## RE: Vivian Sand Facility Project – Environment Act Proposal (EAP) Application File: 6057.00: Updated Rail Loop Design Information

On behalf of CanWhite Sands Corp. ('CanWhite'), this letter provides updated information on the rail loop component design.

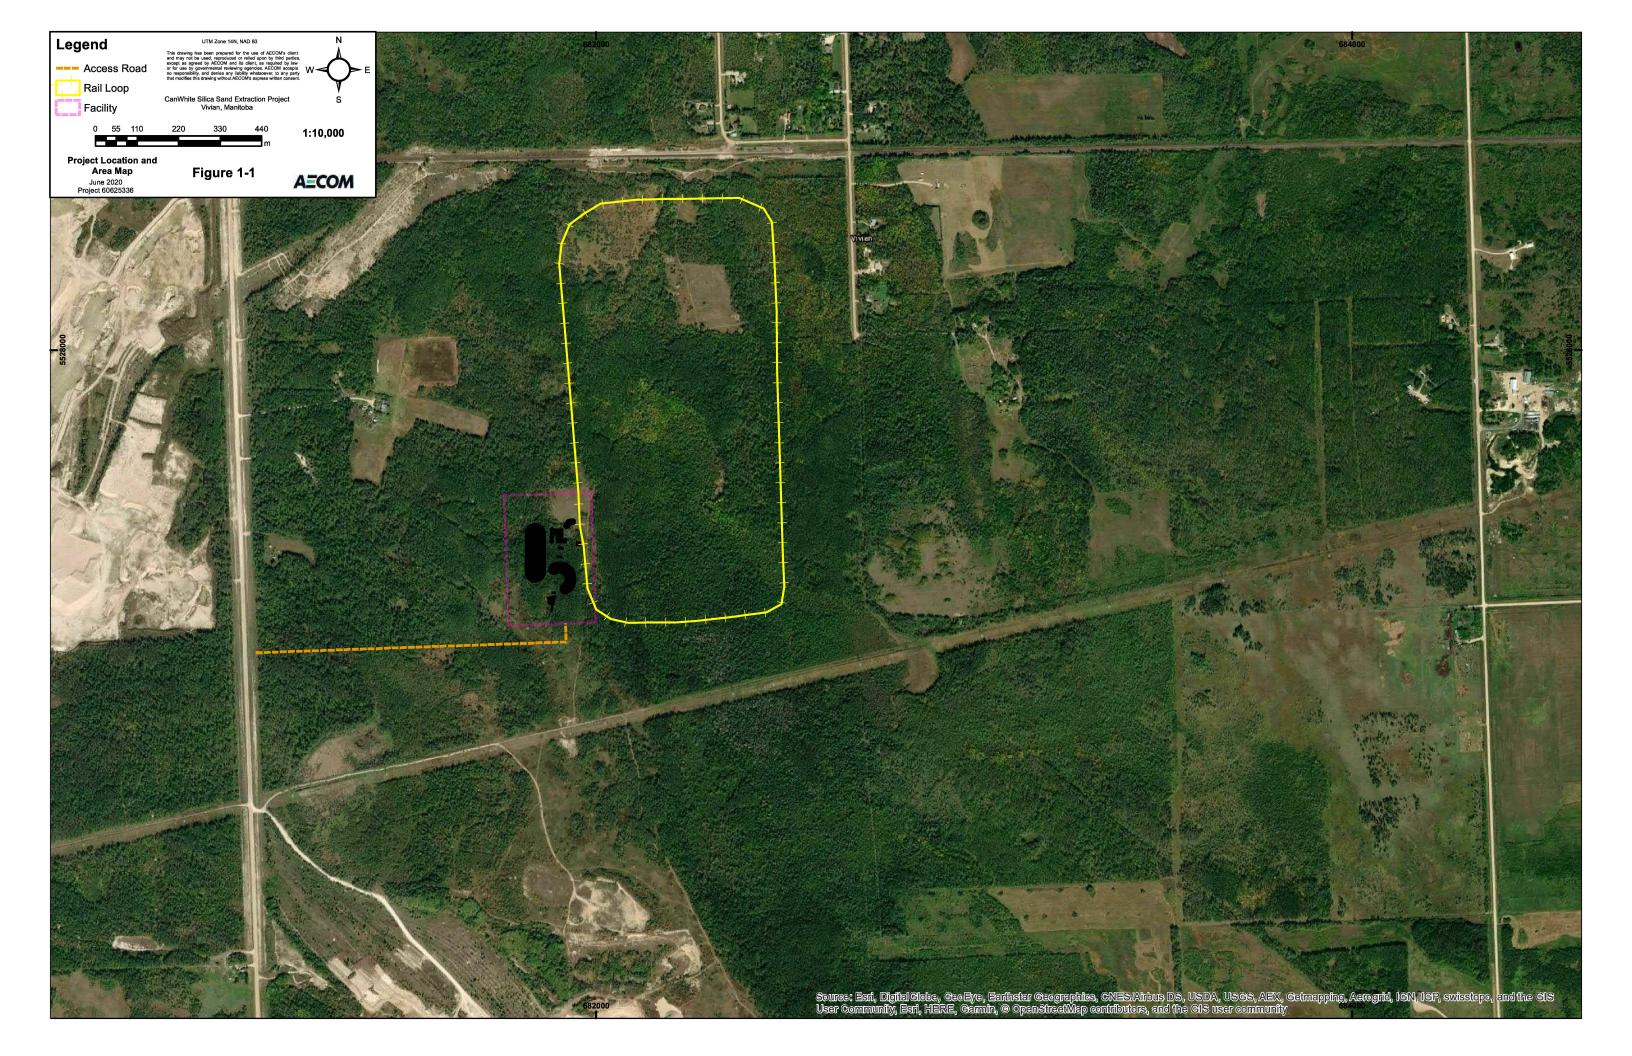
The revised, smaller rail loop from the Noise Impact Assessment (Figure 1-1 of Appendix C of the EAP) is attached. Although the incorrect figure was included in the main body of the EAP, the information provided in Section 6.3.3 (Noise) in the EAP remains unchanged as the smaller rail loop design from Appendix C of the EAP was used to complete the noise modelling and environmental assessment for this Project.

Since submission of the EAP, more detailed drawings for CN Rail's review and approval for the rail loop have been completed. The more detailed rail loop design figures identified as 'Rail Concept Option 4' are attached as Figure 1 and Figure 2 for your reference and is the rail loop represented in the Noise Impact Assessment in the EAP. 'Rail Concept Option 4' also includes two short inner tracks that serve as service/maintenance track for CN Rail use only. This is a requirement by CN Rail. There are no railcar loading facilities situated over this section of track.

Based on the more detailed rail loop drawings (attached 'Rail Concept Option 4'; Figures 1 and 2), the calculated footprint area for the rail loop will be approximately 3 ha smaller than the footprint of the rail loop as presented in Table 6.4 of the EAP. The estimated footprint of all infrastructure components

As shown in the attached 'Rail Concept Option 4' Figure 1, the total area including the footprint of the rail loop and all land area within the rail loop including the rail spur¹ connecting the rail loop to the existing CN Rail mainline is 47.1 ha. This area is 2.9 ha smaller than the minimum required total area of a 'railway yard' to be considered for federal review (total area of 50 ha or more), as described in the *Physical Activities Regulations* of the federal *Impact Assessment Act*. Based on the total area of the rail loop, which including the rail spur is less than 50 ha, in addition to our opinion that the proposed rail facilities for the Project do not constitute a 'railway yard', it is our opinion that this Project does not meet the criteria to trigger a federal review by the Impact Assessment Agency of Canada.
